**Committee of Experts on the Transport of Dangerous Goods
and on the Globally Harmonized System of Classification
and Labelling of Chemicals**

**Use of the Manual of Tests and Criteria in the
context of the GHS: Proposed amendments to Part
II of the Manual**

Note by the secretariat

1. Reference is made to document ST/SG/AC.10/C.3/2014/61–ST/SG/AC.10/C.4/2014/8.
2. This document contains the suggested amendments to Part II (Sections 20 to 28) of the Manual

Figure 20.1 (a): RG7 Flow-chart scheme for self-reactive substances and mixtures and organic peroxides

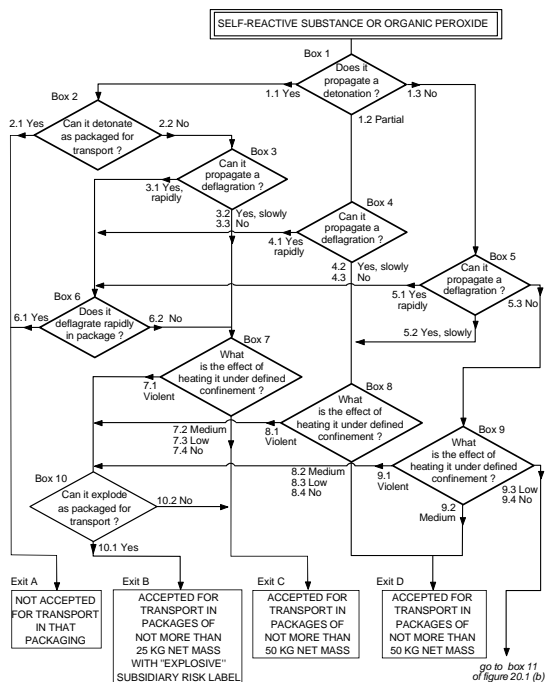
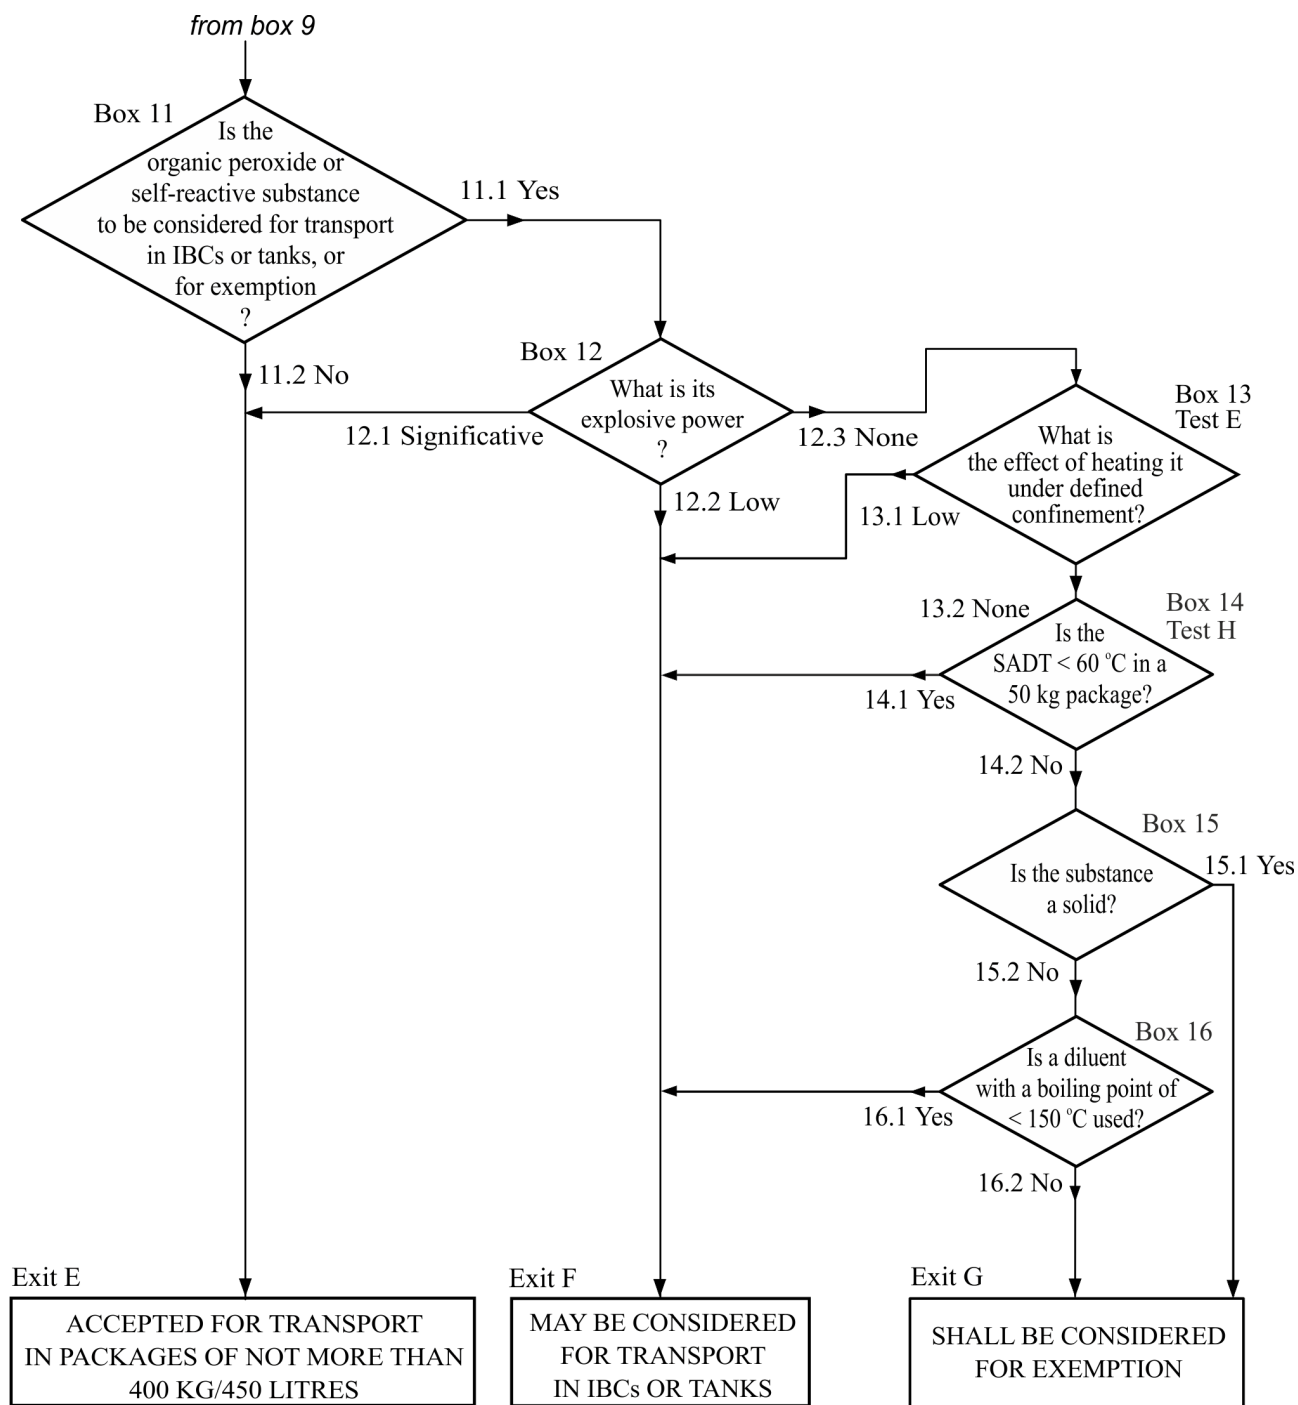
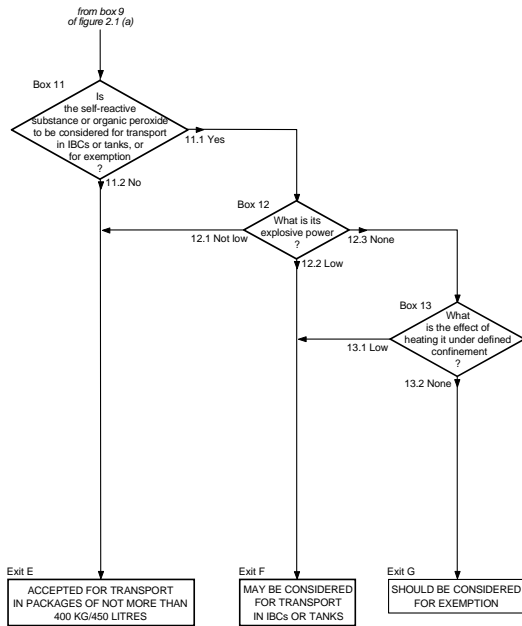
Figure 20.1 (b)^[RG8]: Flow-chart scheme for self-reactive substances and mixtures and organic peroxides (cont'd)
